# CITY OF ALBUQUERQUE

**Re: West Mesa Ridge Apartments**  
**701 Coors Blvd NW, Albuquerque NM 87121**  
**Traffic Circulation Layout**  
Engineer's/Architect's Stamp 05-29-24 (J11D048)

Based upon the information provided in your submittal received 06-12-24, the above referenced plan cannot be approved for Building Permit until the following comments are addressed:

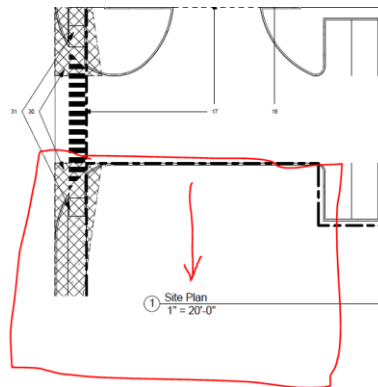
1. Provide an approved infrastructure list.
2. Show the location/details of main entrance to the facility.
3. Provide the agreement from the adjacent property owner since you will be using the highlighted area for construction work.

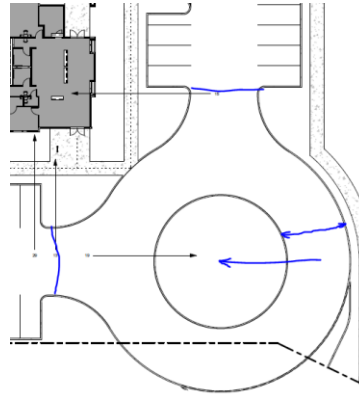
11. Show existing driveways on the adjacent properties and properties across the street from the site. Indicate distancing from these existing driveways to nearby
12. Show all drive aisle widths and radii. Some dimensions are not shown.
13. The minimum drive aisle dimensions are shown below
